Aircraft overflight noise (Marshall Day Acoustics)

WESTERN SYDNEY SECOND AIRPORT DRAFT EIS
OVERFLIGHT NOISE PEER REVIEW
Rp 001 R01 2015417ML | 27 November 2015

Project: **WESTERN SYDNEY SECOND AIRPORT DRAFT EIS PEER REVIEW**

Report No.: **Rp 001 R01 2015417ML**

Figure 3-1 - Ground-based operational noise source locations, 2063 (reproduced from Appendix E2 Figure 3-4)

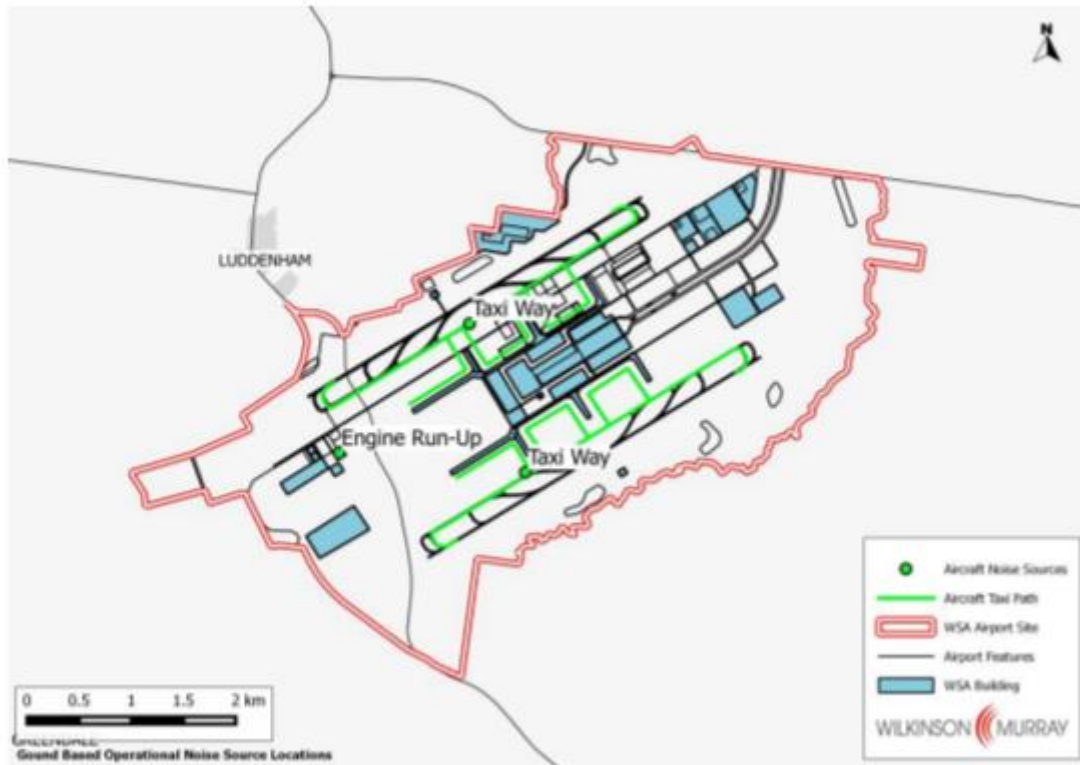
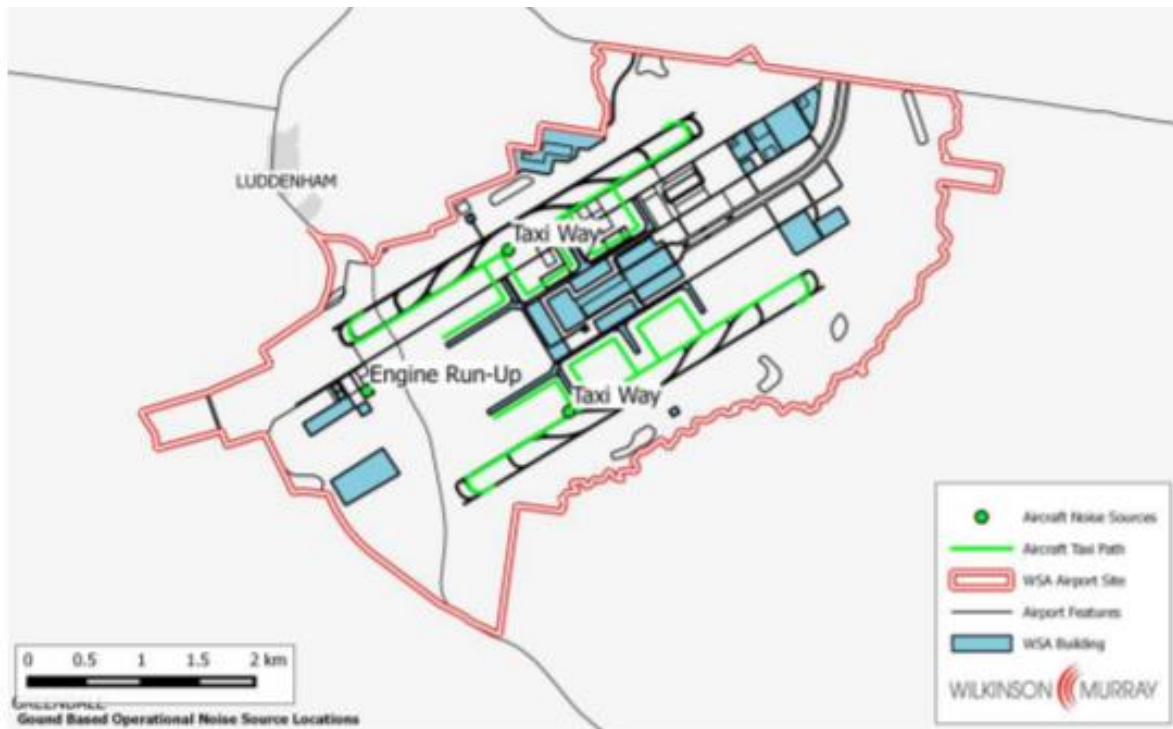
Engine ground run-up noise in 2063 has been modelled at the location indicated in Figure 3-4 of Appendix E2, shown below in Figure 3-1. Figure 3-5 of Appendix E2 shows the noise propagation from this source but does not have the same level of acoustic screening afforded by nearby buildings as that shown in Figure 3-2 of Appendix E2, which is the corresponding noise contour plot for the single runway scenario. These two figures are compared in Figure 3-2 below). There is therefore uncertainty regarding the level of screening from buildings.

Clarification is also required regarding the assumption that, in the event of a two runway airport, there would continue to only be one ground run-up area.

Figure 3-4 of Appendix E2 does not accurately represent Figure 5-3 of the draft EIS Volume 1 (p143) document which shows the indicative airport site layout – long term development. The two figures are compared in Figure 3-3 below. In particular, there are additional areas within that layout where aircraft would be taxiing that have not been included in the noise model. The model only accounts for the usage of 63 out of 95 aircraft gates. It is recommended that the model is updated to include the additional areas where aircraft will be taxiing. It is anticipated that there will be an increase of approximately 1 dB in including these additional areas.

3.7 / Figure 3-4	The figure shows ground-based operational noise source locations in 2063	The figure does not accurately represent Figure 5-3 of the EIS Volume 1 (p143) document which shows the indicative airport site layout – long term development. In particular, there are additional areas within that layout where aircraft would be taxiing that have not been included in the noise model. The model roughly only accounts for the usage of 63 out of 95 aircraft gates.	It is recommended that the model be updated to include the additional areas where aircraft will be taxiing.	Low

Figure 3-2 - Comparison between worst-case $L_{Aeq,15min}$ engine ground running noise contours for 2030 (single runway, left) and 2063 (two runway, right)

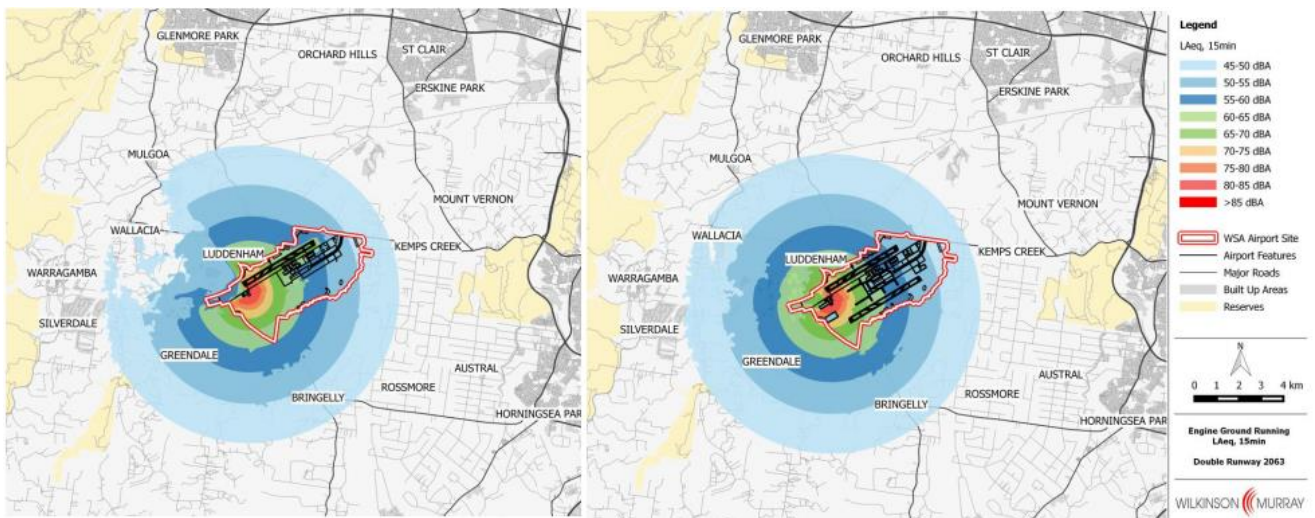
3.7 / p17, para 2, Figure 3-4, Figure 3-5	<i>"Ground-based noise levels have been predicted for the longer term airport development using the same methods as for the initial airport development. The noise source locations are shown in Figure 3-4 and the resulting contours are shown in Figure 3-5 and Figure 3-6."</i>	The text infers that, even with two runways and a significant increase in aircraft movements as a result, there would still be only one engine run-up for less than 5 minutes in any 15 minute period. This single point source of noise has been modelled as indicated in Figure 3-4, however Figure 3-5 (which shows the noise propagation) does not appear to have the same level of acoustic screening from nearby buildings as the similar situation in Figure 3-2, which suggests that either Figure 3-2 overestimates the level of acoustic screened afforded by buildings, or Figure 3-5 underestimates this.	Clarification that, in the event of a two runway airport, there would continue to only be one ground run-up area. Confirmation that the acoustic screening from buildings has been correctly accounted for in both Figure 3-2 and Figure 3-5	Medium
